TRANS/WP.29/GRSG/2005/18  
25 July 2005

COMMENTS ON THE DRAFT REGULATION ON  
UNIFORM TECHNICAL PROVISIONS CONCERNING  
THE FORWARD FIELD OF VISION OF DRIVERS

Transmitted by the expert from India

Figure -1

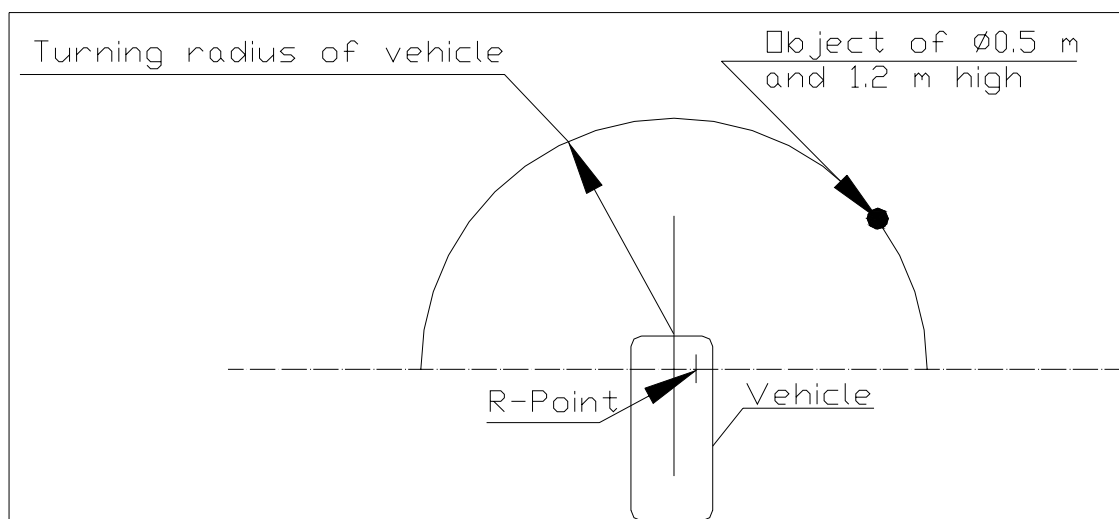
1. The method should be common for all the vehicle categories.
2. Method and measurement to be simple practical and easily repeatable, even in the in-use vehicles for enforcement.

When an critical object of size 0.5 m diameter and height of 1.2 m is moved along the turning radius of the respective vehicle, at least 50 per cent of the object should be visible along either longitudinal axis or in the lateral axis.
